Administrative Staff Report

Project Name: Clear Creek Road Apartments

Type of Application: Administrative Conditional Use Permit

Permit Number: 19-04767

Revised Transit Walking Route Diagram

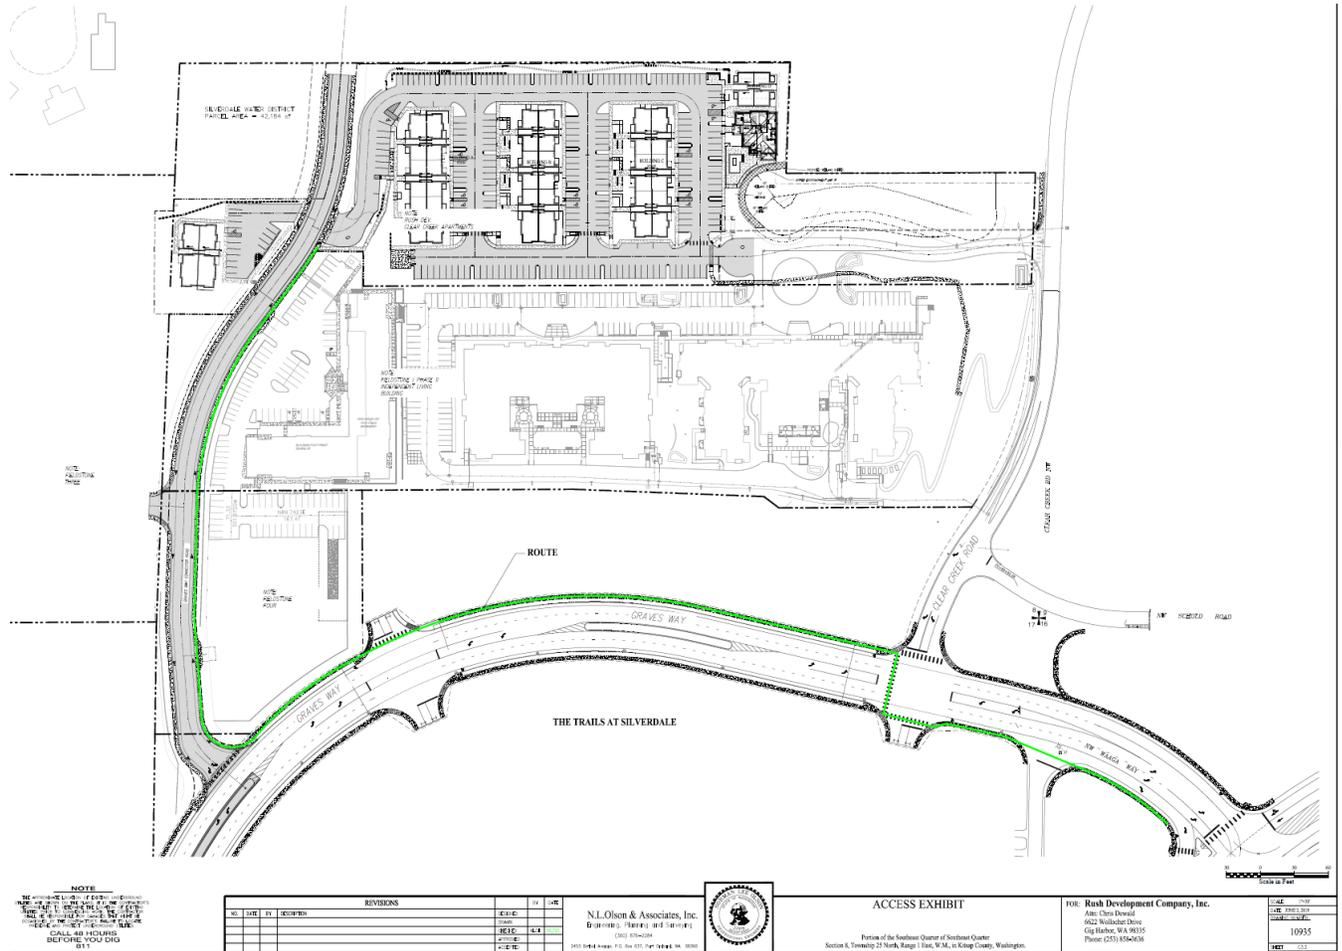
Staff Response: The applicant's response demonstrates justification for the 25% reduction based on the unit type, access to transit routes traffic engineering. The applicant submitted an updated Transit Walking Route diagrams in response to SEPA Traffic and Right-of-Way Mitigation condition #8. The updated document provides accurate information on the direct route to Greaves Way vs. the older diagram. The SEPA condition is satisfied and no longer applicable. It was unclear if the projections considered demand for visitor parking. Staff recommends the 18 additional parking spaces (240 parking spaces total) to remain as a safety factor until visitor parking trends are established.
